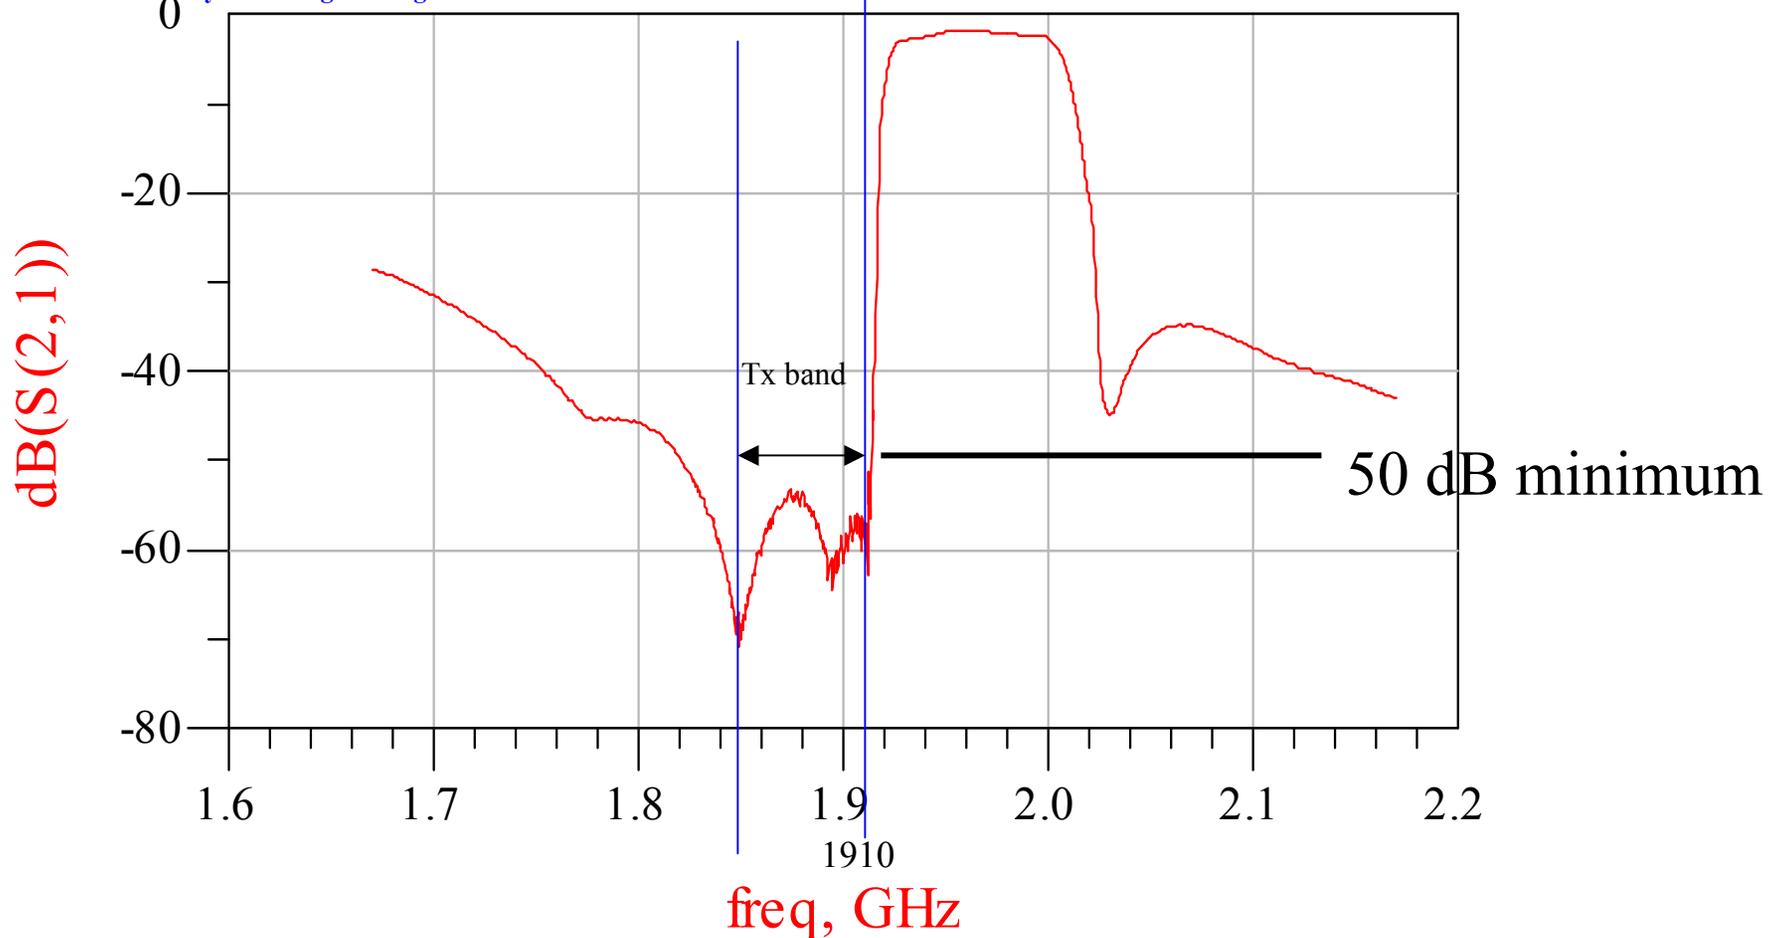
- Agilent claims 37dB min can be obtained short term by sorting (Gain slope steeper in some units) and possibly longer term can be supported with design change and new TC in 2 years
- High Risk in new single sourced sorted filter or new design with no quote in hand.
- Split band filters can solve duplex noise problem but not Rx noise from G band Tx's

- Rx filter also needs tweak/sort with associated risk
- Split band filters viable
  - but expensive option in \$ and size
  - performance degradation due to extra losses
